STAFF RECOMMENDATION
1906 Bernard Avenue
January 18, 2016

Application: New construction—infill
District: Hillsboro-West End Neighborhood Conservation Zoning Overlay
Council District: 18
Map and Parcel Number: 10412015100
Applicant: Michael C. Rhodes
Project Lead: Melissa Baldock, melissa.baldock@nashville.gov

<p>Description of Project: Application is to construct a duplex infill.</p> <p>Recommendation Summary: Staff recommends disapproval of the project, finding that the height, scale, proportion and rhythm of openings, and foundation material do not meet Section II.B. of the design guidelines for the Belmont-Hillsboro Neighborhood Conservation Zoning Overlay.</p> <p>The Commission does not have the authority to approve the use. This recommendation is for the design of the building based on the proposed use.</p>	<p>Attachments A: Photographs B: Site Plan C: Elevations</p>
--	--

BELMONT HEIGHTS SITE PLAN

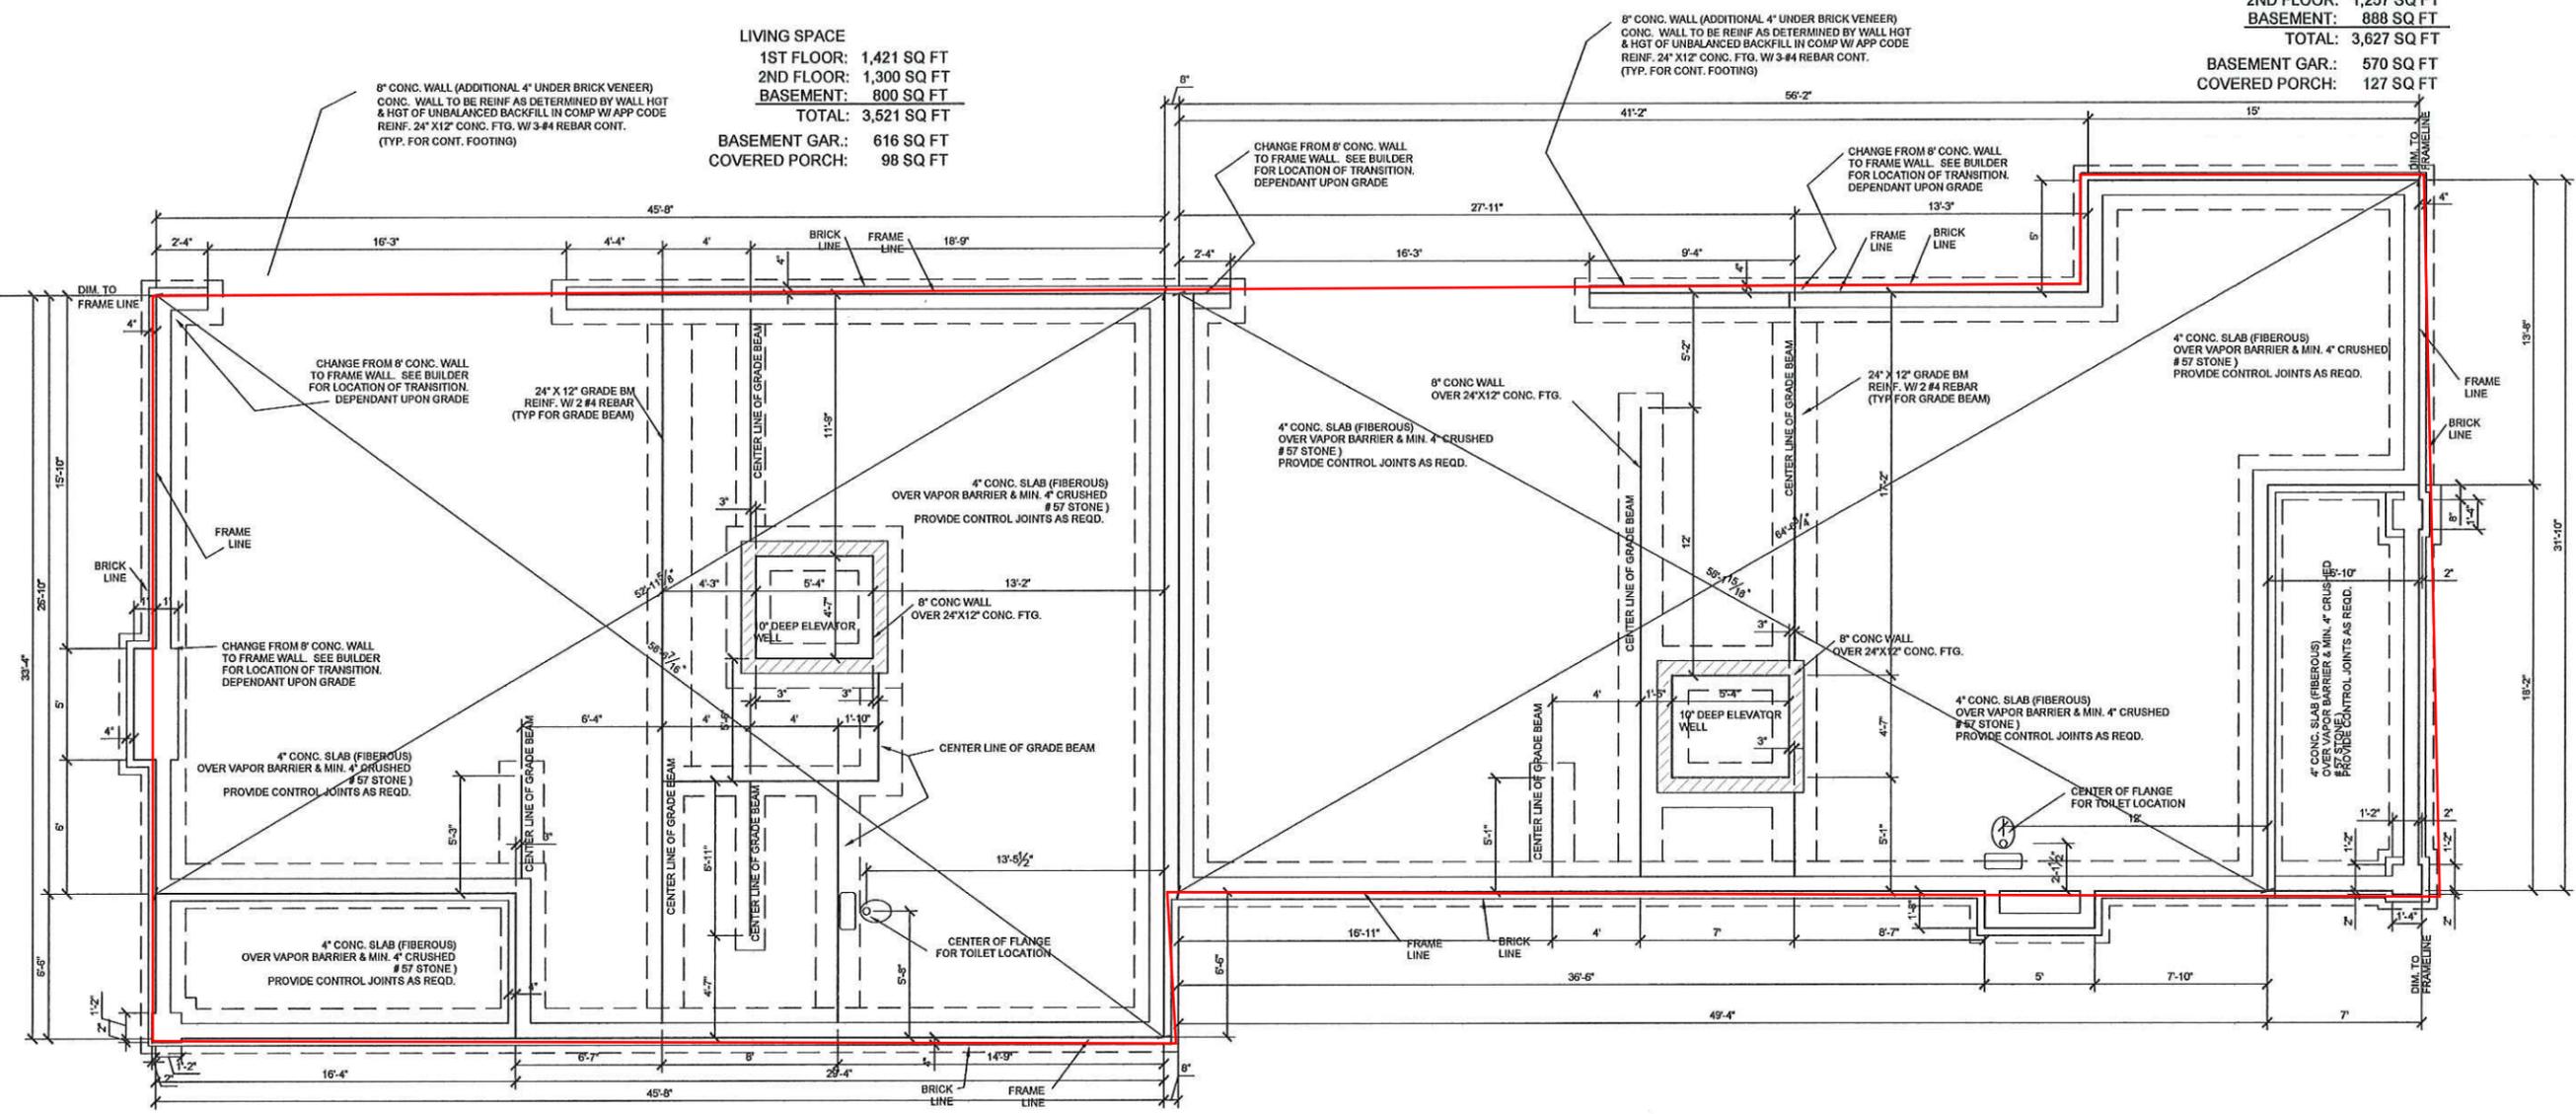
Setback & Rhythm of Spacing: The proposed infill meets all base zoning setbacks. It is a minimum of five feet (5') from the left side property line and a minimum of seven feet (7') from the right/side alley property line. The garage doors that face the side alley are more than ten feet (10') from the alley, which meets the base zoning setbacks. The infill will be twenty-five feet, three inches (25'3") from the rear property line.

Because there are no other houses that face Bernard Avenue, there is more leeway with the appropriate front setback. The applicant is proposing to situate the infill approximately twenty feet, six inches (20'6") from the front property line. This is a few feet forward of the structure previously on the lot. However, the front façade will be several feet behind the side facades of the houses next door, which face 19th Avenue

FRONT ELEVATION
SCALE: 1/4"=1'-0" (18"X24" SHEET)
SCALE: 1/8"=1'-0" (8.5"X11" SHEET)

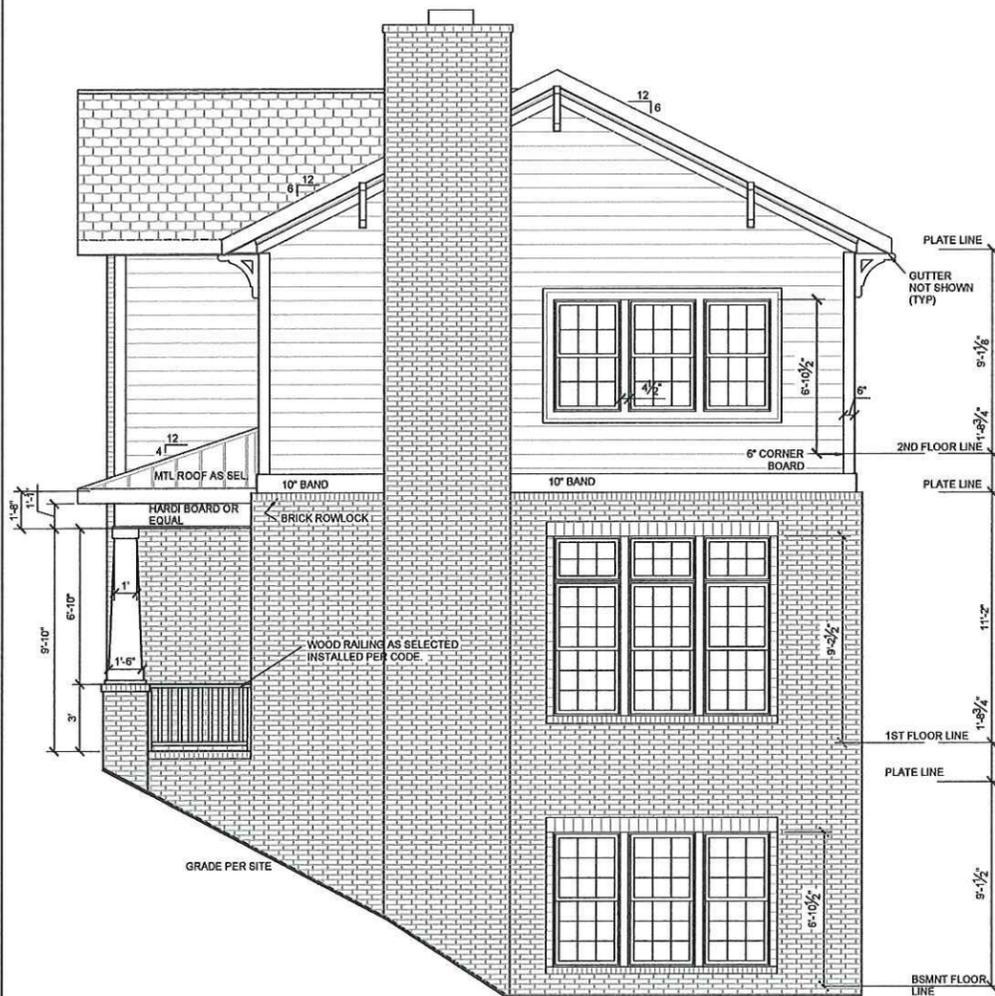
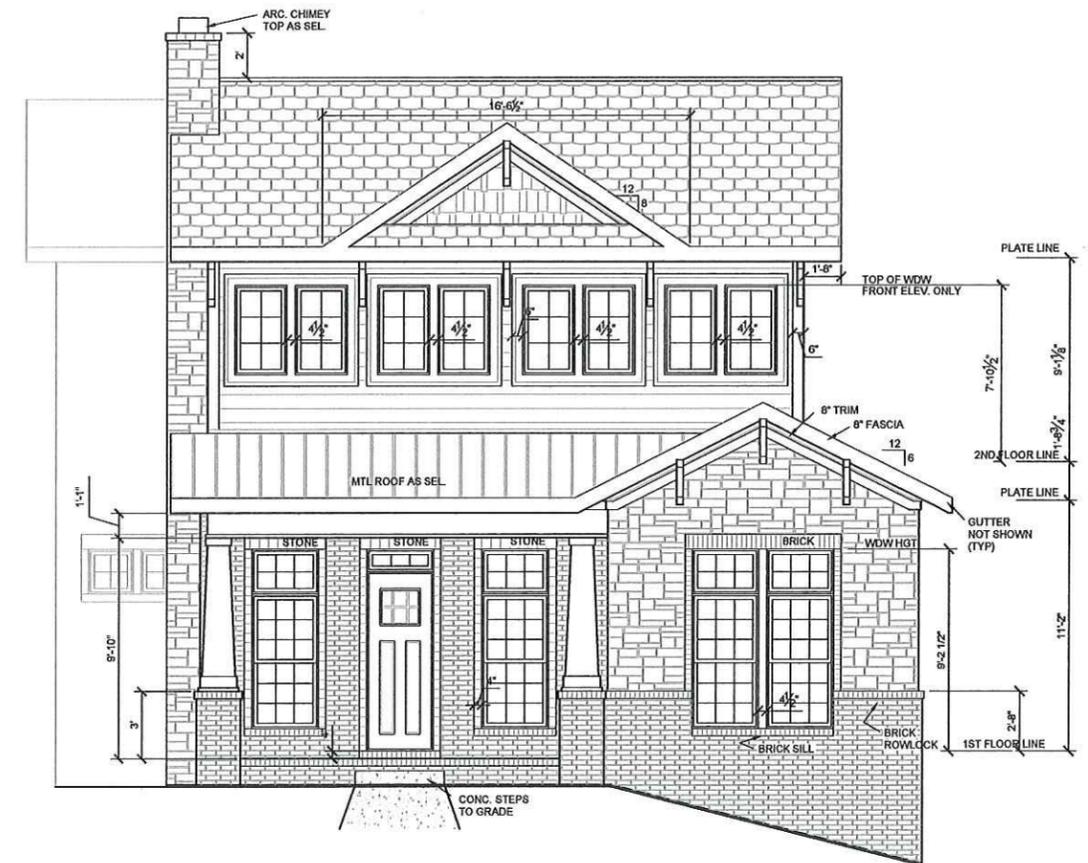
Height & Scale: The proposed infill is two stories at the front, and because there is a slope to the site, the right/side alley-facing façade is three stories. Although there is a one-story bay at the front, the predominant form of the house is that of a two-story structure. The infill has an eave height of over twenty-three feet (23') and a ridge height of thirty-one feet (31'), measured from grade at the front. Because of the slope of the site, on the right/side alley façade and at the rear, the house is over forty feet (40') tall.

Staff finds that the proposed height does not meet the historic context. Historic houses in the immediate vicinity are predominantly one-and-a-half stories in height, with heights between twenty-two and thirty feet (22'-30'). Although there is a three-story apartment building across the street, staff finds that the new infill at 1906 Bernard Avenue should fit in with the historic character and scale of the single family and duplex houses in the immediate vicinity. In addition, because the lot is smaller in area than surrounding lots, the infill should maintain a modest size. Any infill on this site should be one-and-a-half stories and around twenty-five feet (25') tall.

The two-story form of the house, its overall height of thirty-one feet (31') at the front, and the large depth and overall footprint combine to make the proposed infill out of scale for the immediate context. Staff finds that the infill's height and scale do not meet Section II.B.1.a. and II.B.1.b. of the design guidelines for the Belmont-Hillsboro Neighborhood Conservation Zoning Overlay.

*The applicant is proposing a brick foundation with brick walls above. Typically, the Commission has asked for a change in material at the foundation line to differentiate the foundation from the wall above. The continuous brick wall accentuates the height of the house, which is already out of scale, particularly on the right/side alley façade. In addition, the front bay is partially clad in stone, and the change in material from brick to stone occurs about three feet (3') above the floor line. It is more typical for the change in material to occur at the foundation line.

**The reveal of the lap siding was not called out on the elevations, but it measures to be six inches (6") or larger. The design guidelines states that lap siding should have a maximum reveal of five inches (5").

In order for the project to meet Section II.B.1.d. of the design guidelines, there would need to be a change in material from the foundation to the wall above, the change in material on the bay would need to occur at floor level, and the lap siding would have to have a maximum reveal of five inches (5"). In addition, staff would have to approve a brick sample, a stone sample, the shingle color and texture, the metal roof color and texture, and all windows and doors prior to purchase and installation.
